CITY OF ALBUQUERQUE

**Re: Del Webb @ Mirehaven Units 3 & 4
Grading and Drainage Plan Engineer's Stamp dated: 7/9/2018, Drainage
Report Engineer's Stamp dated 5/10/2018, and Amendment #1 to the
Drainage Report Engineer's Stamp dated: 9/18/2018 (H09D017G)**

Re: Del Webb at Mirehaven Phase 3&4 Grading and Drainage Plan and Drainage Report
Engineers Stamp Dated: 05/10/2018 (H09D017G)

DRAINAGE MANAGEMENT PLAN FOR DEL WEBB @ MIREHAVEN PHASES 3 AND 4

DEL WEBB @ MIREHAVEN PHASE 3
PROPOSED BASINS MAP
JUNE 2018

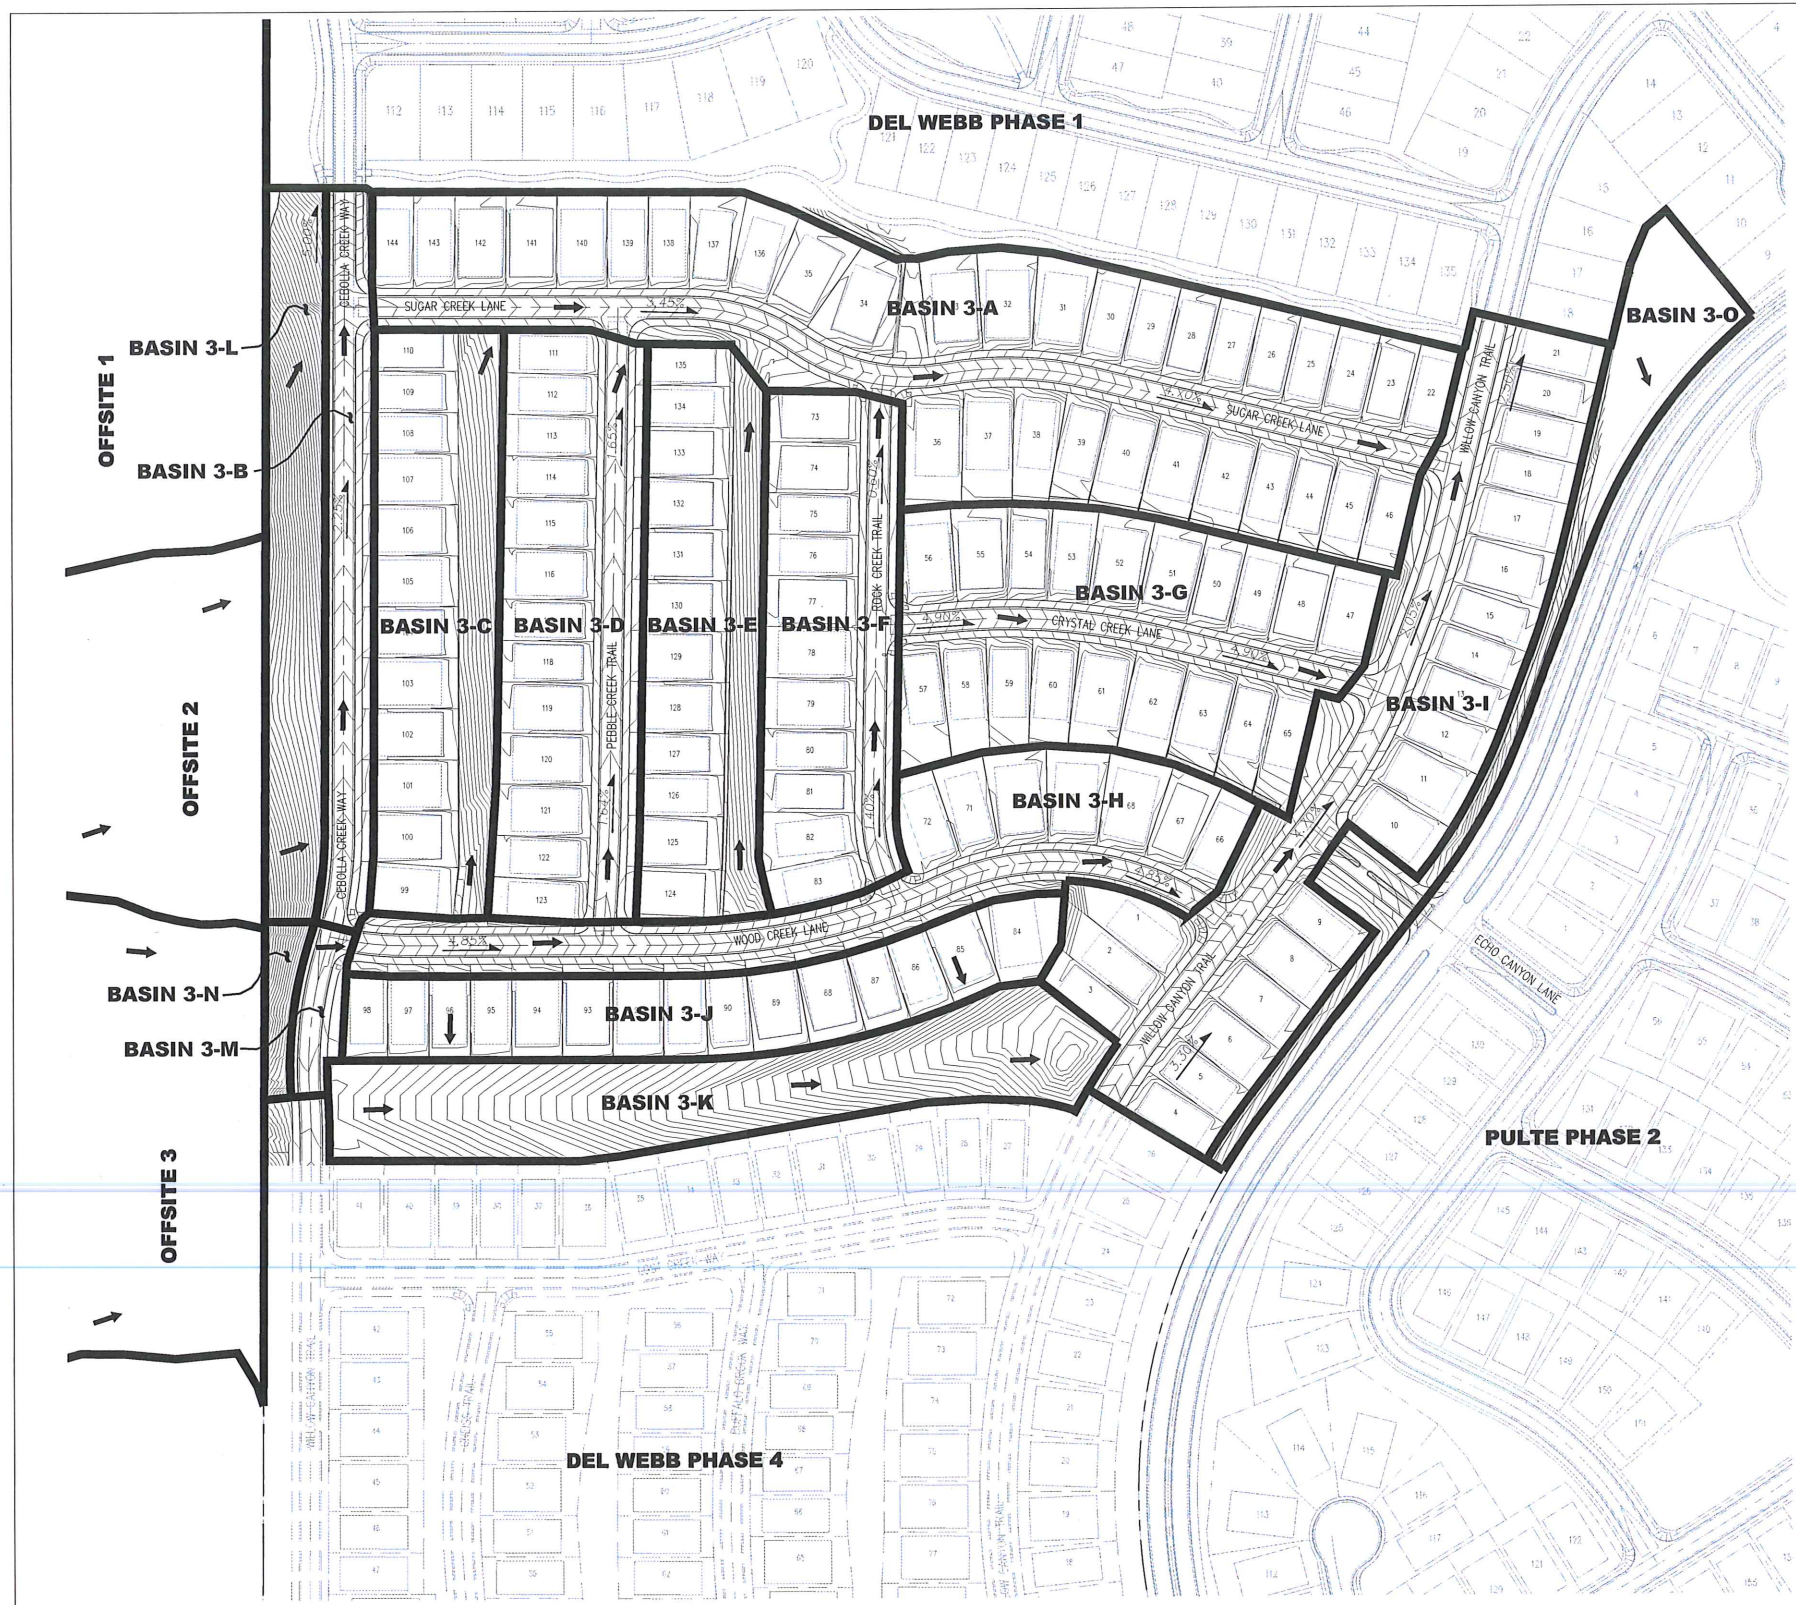
4. The Drainage Report for Units 3 & 4 does not address the effects of this development on downstream capacity. Representatives of the Unit 3 & 4 development stated in meetings that the downstream capacity was demonstrated in other reports, specifically the West 1-40 DMP and the 2013 Drainage Master Plan for the Watershed Subdivision. However, the hydrology from the West 1-40 Drainage Management Plan, as referenced in the 2013 Drainage Master Plan for the Watershed Subdivision, does not account for either the increased density of this development nor the increased area draining to the Mirehaven Arroyo. **The West I-40 DMP developed the basin which were allowed to discharge to Ladera Dam 12. The Mirehaven Masterplan analyzed the entire Q for this area as well as the Mirehaven Arroyo which was review and approved by the City of Albuquerque and set forth the requirements for each subdivisions within the Masterplan. We are adhering to that Masterplan in this report. We cite flows allowances and provided exhibits within the report from this Master Plan and Del Webb Phase 1 approved reports which indicated that we are below the allowable Q100 for Del Webb Phases 3 and 4. Additional, specific information is provided below.** Therefore, pursuant to article 14-5-2-12(0) of the Albuquerque Code of Ordinances which states "The City Engineer shall not approve any plan or report pertaining to proposed construction, platting or other development where the proposed activity or change in the land affected would result in downstream capacity being exceeded", neither the Final Plat nor the Work Order can be approved until downstream capacity has been demonstrated in accordance with the standards established in the DPM.

The Drainage Report for Units 3 & 4 must be modified to include corrected basins for the Mirehaven watershed in accordance with the standards established in the DPM instead of using in the referenced West 1-40 DMP, as was done in the 2013 DMP. The basins must be corrected to show the higher density of this development and the increased area draining to the Mirehaven Arroyo. Downstream capacity must be determined based both on existing and fully developed watersheds for the channel and crossing structures of the Mirehaven. AMAFCA indicated in an e-mail on June 2, 2018 that the capacity of the downstream reservoir is not of concern. If additional infrastructure is required it must be added to the infrastructure list.

The submitted Drainage Report Dated 7-14-18 references the approved Drainage Master Plan for the Mirehaven Master Planned Community (see page 2), which set forth the allowable flows for the future subdivisions within the Mirehaven Subdivision. On Page 4, VI. Developed Conditions, A. Allowable the Final Amendment No. 2 For the above mentioned drainage report indicates an allowable Q100 of 135.9 cfs to the existing 42" SD on Willows Canyon Trail and 33.2 into Mirehaven Parkway which ultimately get picked up at the lowpoint upstream of Del Webb Blvd and into the same storm drain network for total combined Q100 of 168.1cfs. The total Q100 from Del Webb 3 and 4 will be 144.9cfs into the 42" SD in Willow Canyon which is less the combined 168.1cfs combine allowable into the SD network. As noted on page 6 the additional Q100 between the 144.9cfs vs 135.9cfs was analyzed and the additional 9.0 cfs had no impact to the downstream infrastructure information provided in the above mentioned report in Appendix C. Furthermore, as stated above the total flow is 32.2cfs less than what the downstream infrastructure was anticipated and designed for since there is no discharge into Mirehaven Parkway.

As indicated on the Overall Basin Map from the Approved Mirehaven Master Plan Report (which is included in the original report as Exhibit A) Outfall B has an allowable discharge of 277.6cfs. 73.5 cfs was allotted to DW1 and 160.7 was allocated for the future DW3&4, 22.1 cfs for Offsite Basins 2 &3 and 21.4 for Mirehaven Parkway. See enclosed Exhibit A (Drainage Masterplan Overall Basin Map), B (Del Webb 3 and 4 Basin Maps) and C (Del Webb Unit 1 Basin Map), the actual flow from Del Webb 3 & is 147.6 cfs which is below the allowable 160.7cfs per the approved Masterplan. Exhibit A and B are in the above reference report. Exhibit C was added for additional information to supplement the total basin calculations. These exhibits with flow breakdowns are provide in the enclosed Addendum #1.

EXHIBIT D
POND DETAIL

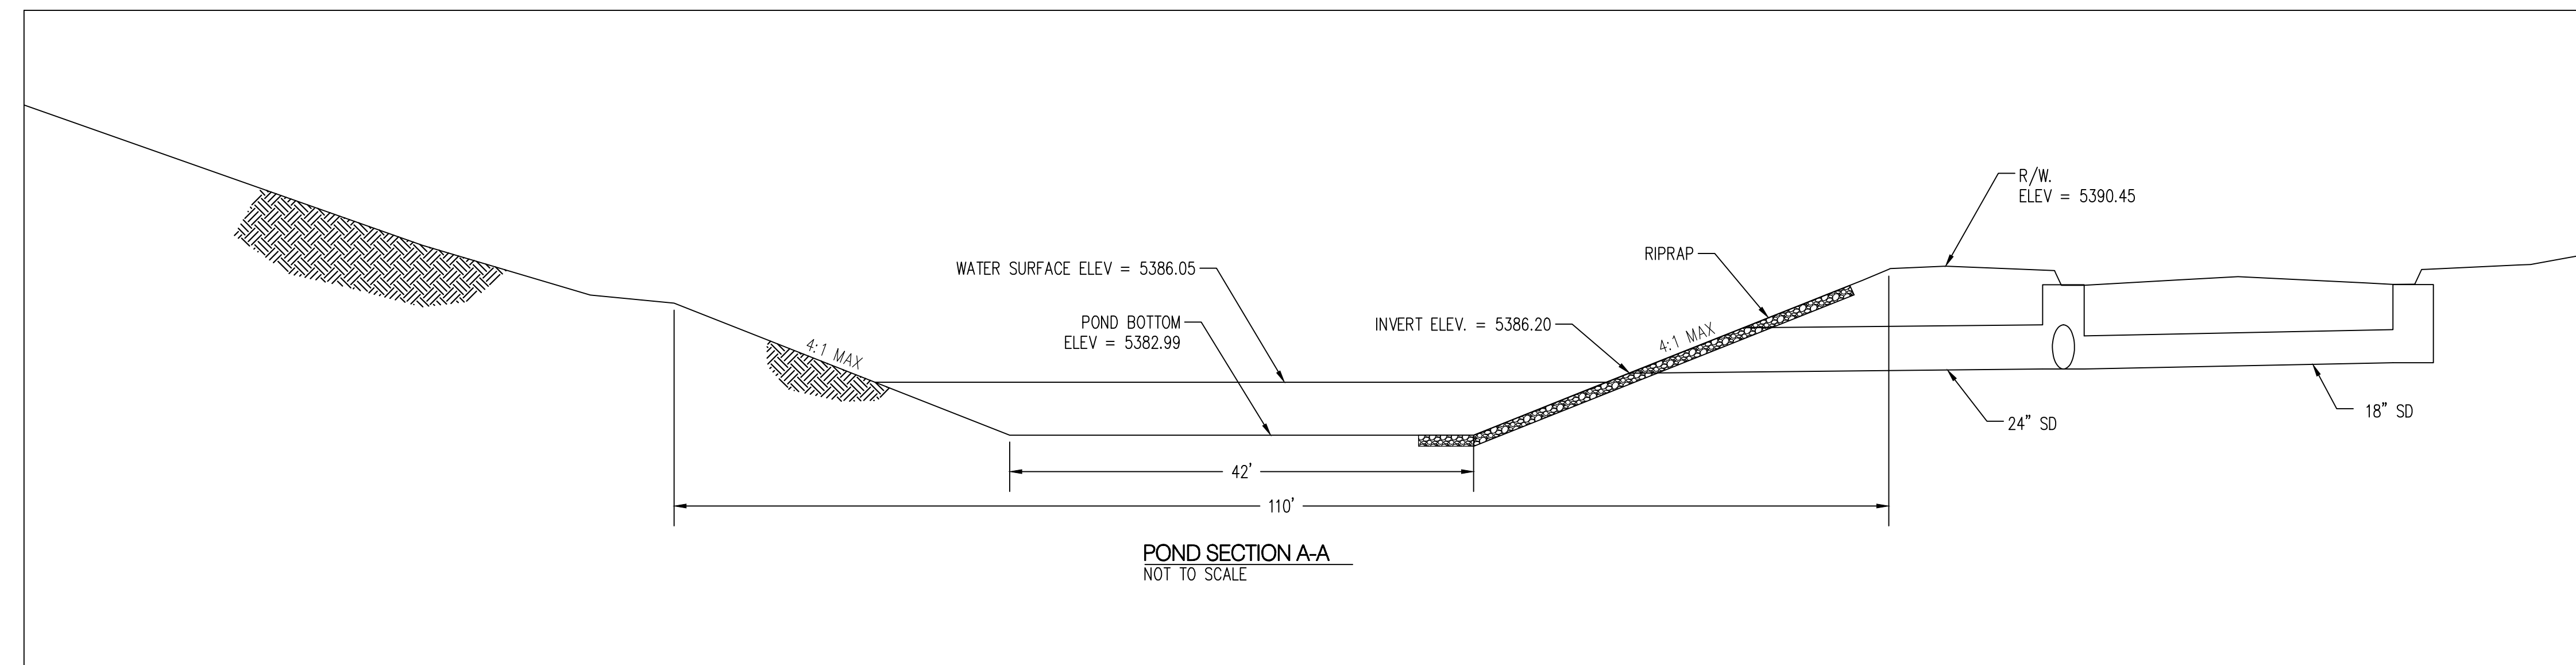
4. Label the inverts of the pipes, the top elevation of the baffle, the normal pool elevation and pond volume, the Q_{100} , and the 100 year water surface elevation on the grading plan and on the pond detail. The 100 year water surface elevation should be based on either weir depth over the baffle or inlet control on the outlet pipe whichever is higher plus losses between the pond and inlet. The calculations and an explanation of the calculations are required in the amendment. A section showing the length of the weir should be added. Hydraulic calculations must be contained in a bound report with an engineer's stamp and signature on it.

5. The invert of the pipe into the pond should be set at the invert of the pond, or provide a concrete rundown between the end of the pipe and the invert of the pond. Riprap is not sufficient to stabilize the slope when subject to concentrated flow and should be only used in the flat part of the pond bottom. Specify the

5. HGL calculations per DPM and profiles showing HGL,. HGLs are shown on the construction plans and the computer output for the HGL calculations are provided in Appendix C in the enclosed Addendum #1.
6. A Detail of the pond outlet structure. Hydraulic calculations must be contained in a bound report with an engineer's stamp and signature on it. Detail of the pond and storm drain are provided in the construction plans and the detail sheet is provided in the enclosed Addendum #1 as Exhibit D. The Pond Volume calculations are provided as Appendix B.

The pond detail requested is enclosed as Exhibit D and the volume is provided in Appendix B.
